Architectural Review and
Historic Preservation Board
Agenda Report

File: PDP 16-04

RE: Recommendation to the Planning Commission for the Urban Apartments Project –
Located at 1033 W. 5th Street & 1046 W. 6th Street (APN 004-202-007 and -018)

SITE PLAN
3/32" = 1'-0" 2

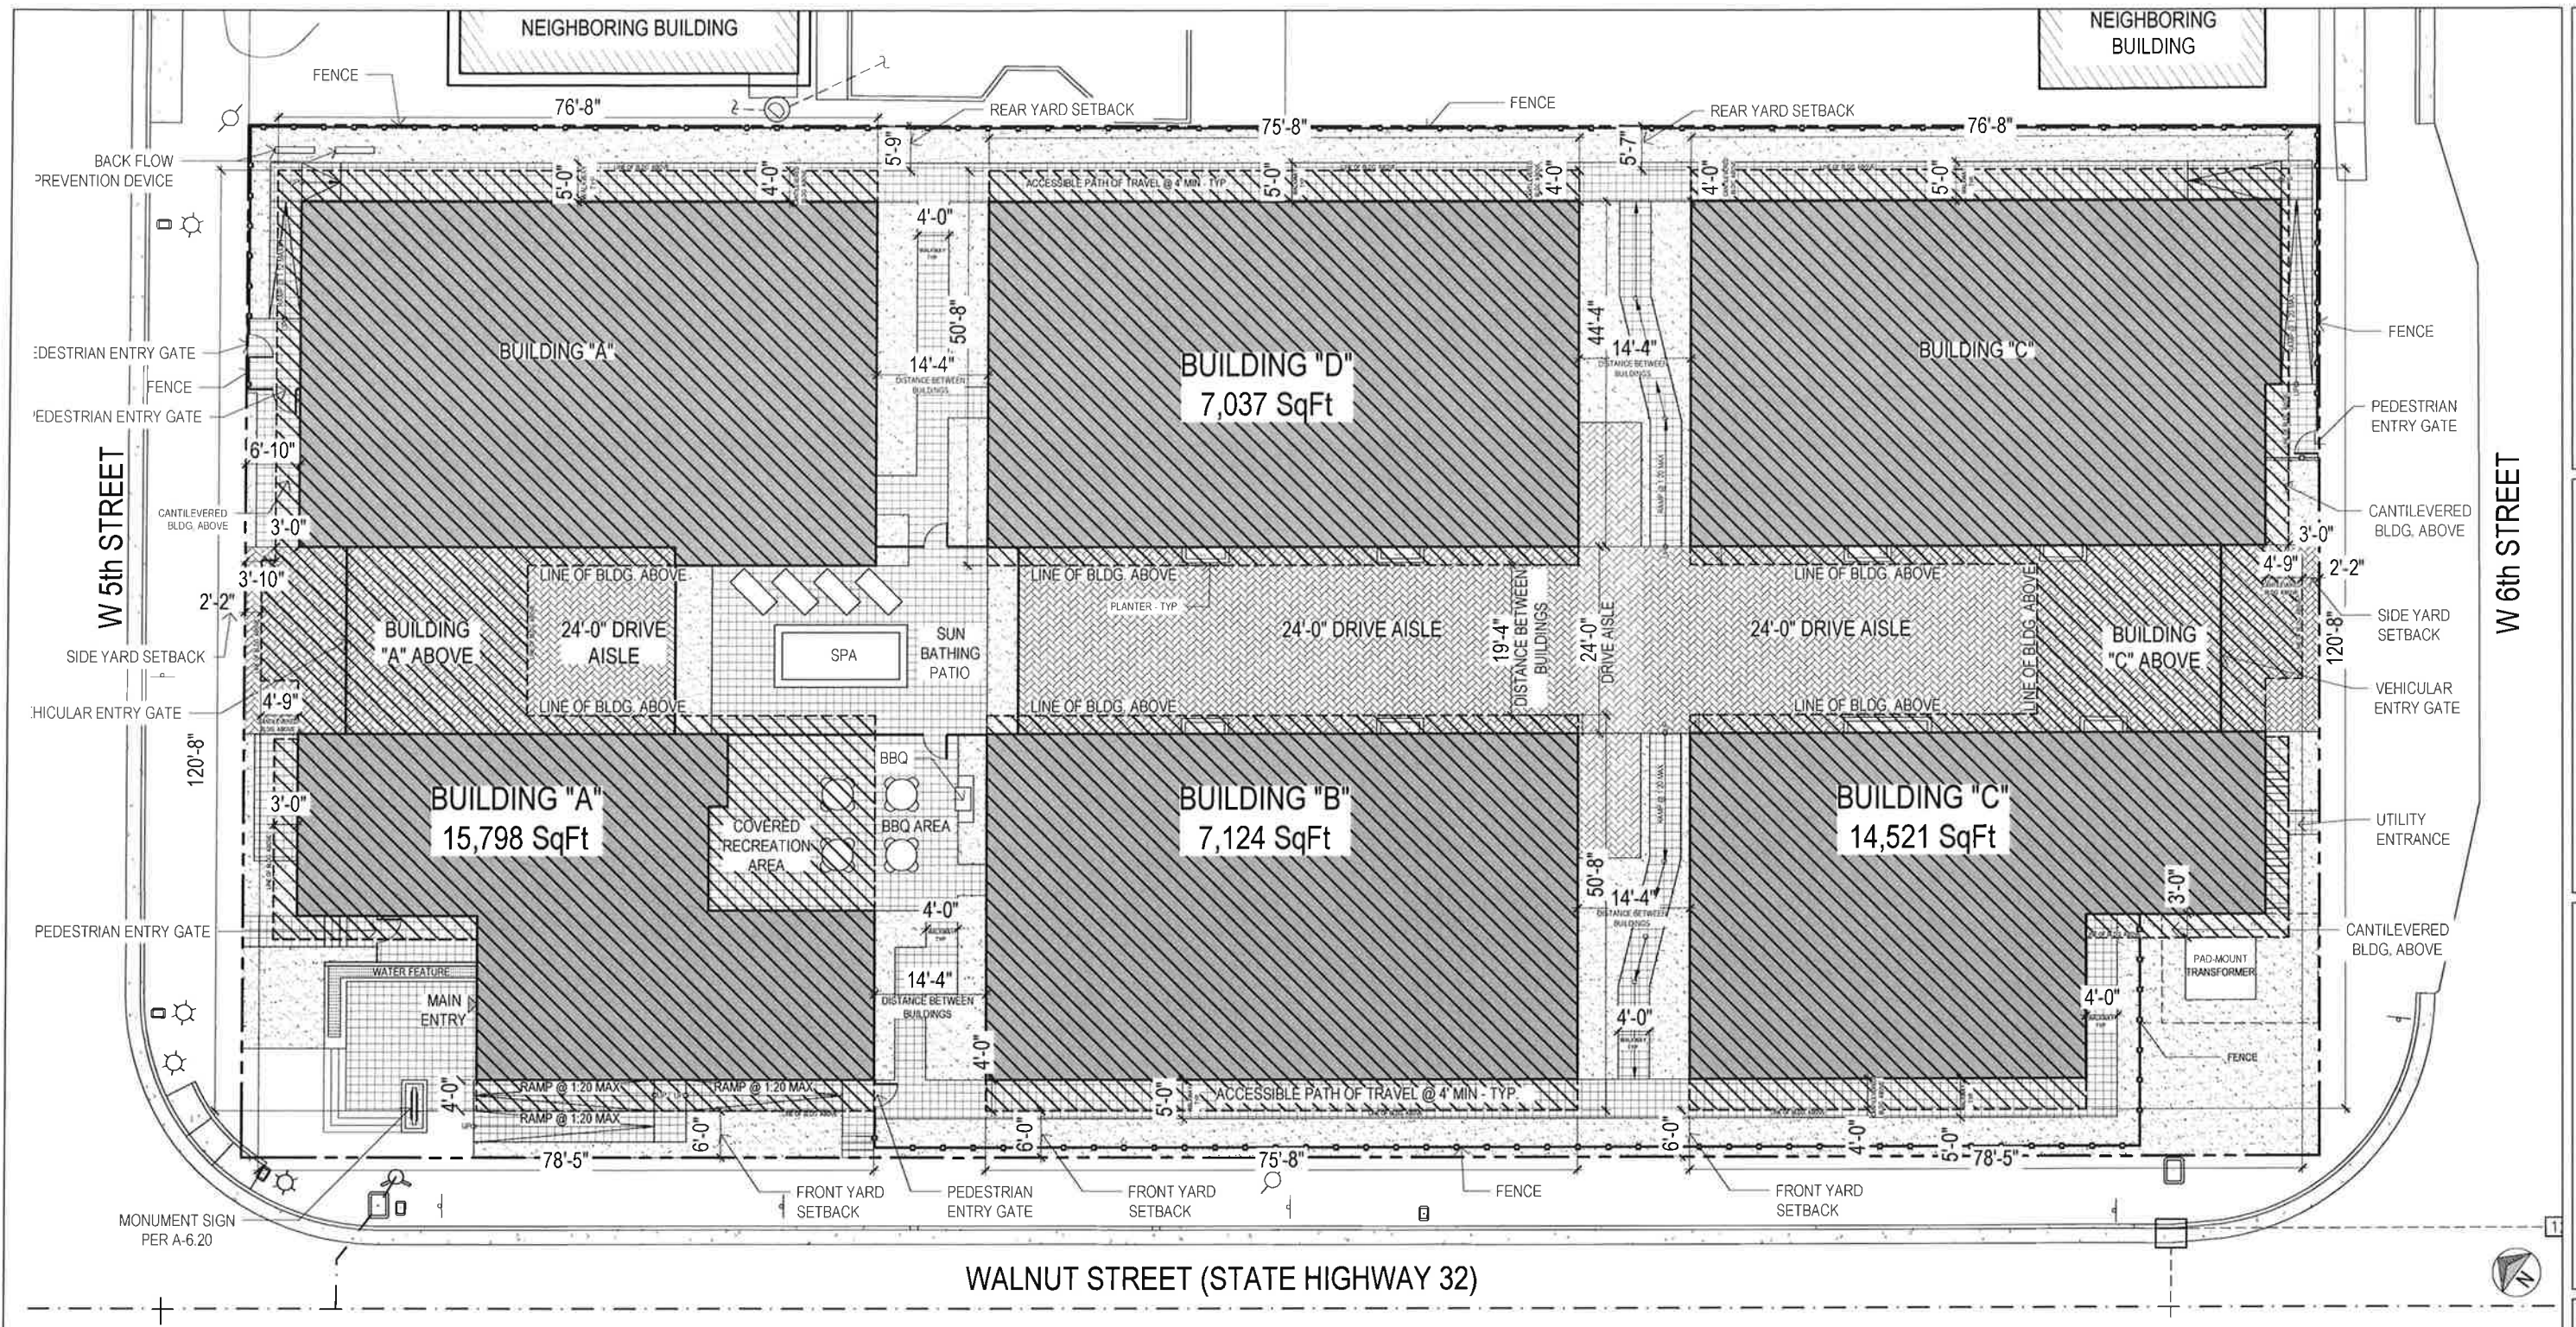
Front-Yard Fence Height: As proposed, the front-yard fencing would exceed the maximum height allowance of 3-feet established by CMC Section 19.60.060 and cannot be approved.

Recommendation: Reduce the height of the fencing proposed in the front-yard (Walnut Street frontage) to comply with the 3-foot height maximum or remove from the project plans.

SHADE STUDY MODEL IMAGES

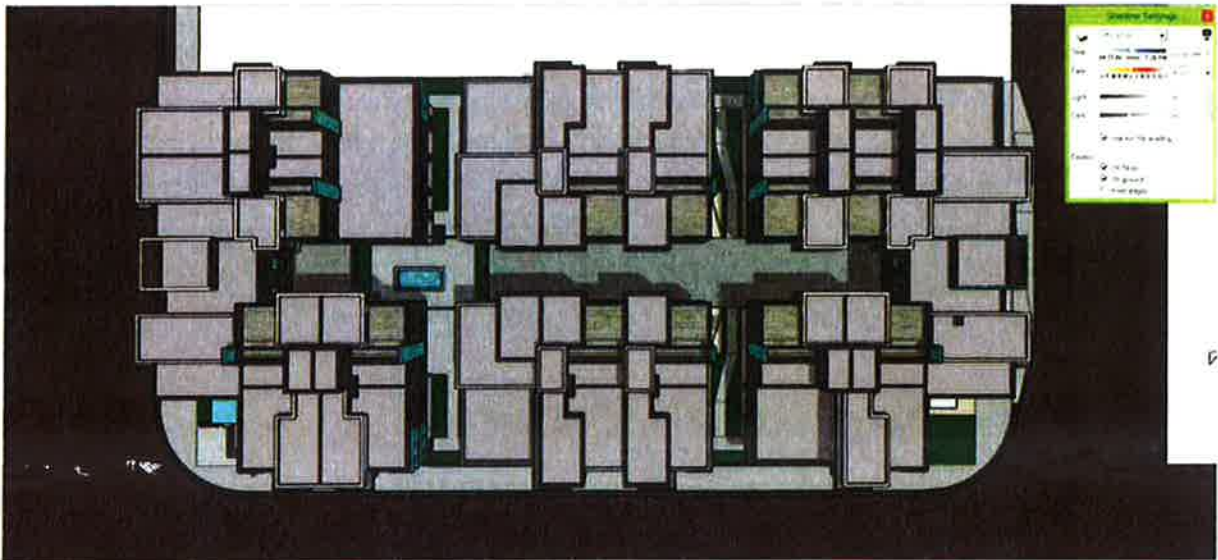
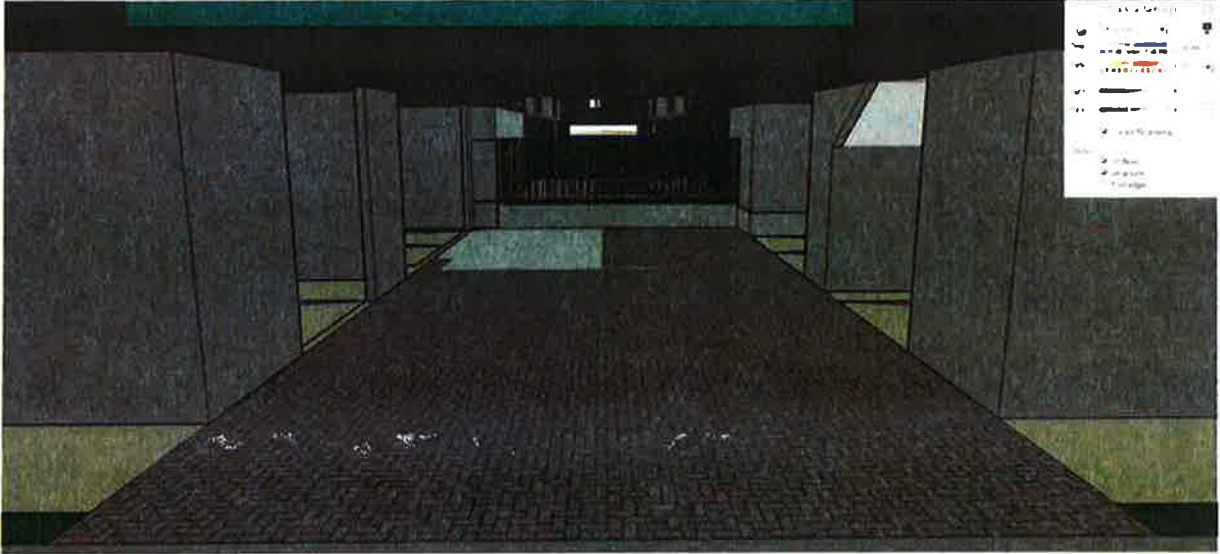
We are requesting code relief from Chico municipal code section 19.70.060E(2) which requires that "...at least 50 percent of the total paving area, not including the entrance drives, parking areas under carports...shall be shaded at solar noon on June 21." We believe that the intent of the code here is to provide a degree of protection from the heat generated due to a vehicle parked in the full sun, and secondly, to protect against the "heat-island" effect of unprotected paving holding and radiating heat for a long duration. We also believe that this code section was drafted with typical at grade parking lots in mind and does not allow for unique building/parking configurations such as those utilized by our proposed project. We firmly believe that our project meets the intent of the code and that support of our request can be made through any one of the code interpretations indicated below.

Should staff not agree with the interpretation in the preceding paragraph then a second solution would be to analyze the shading of the entrance drive aisles at noon on June 21st as the code indicates. As proposed the entrance drive aisles constitute a total area of 5,313 SF with 2,193 SF (41%) of that directly covered by the building. However, this figure does not account for shadows cast by the building which puts a further amount of the entrance drive aisles in shade. Based on solar shade studies done using 3D Modeling software that incorporates solar paths throughout the day/year (see attached Model Images), at noon on June 21st 3,333 SF of the entrance drive aisles are in shade. This results in 63% of the entrance drive aisles being in shade on June 21st at 12:00 noon.

We feel strongly that the intent of the code is being met in that well over 50% of the paved areas provided for parking are in shade at the designated time of day/year. As such we are requesting that planning staff support our PDP request to allow the required shading to be provided by the building in lieu of the required trees.
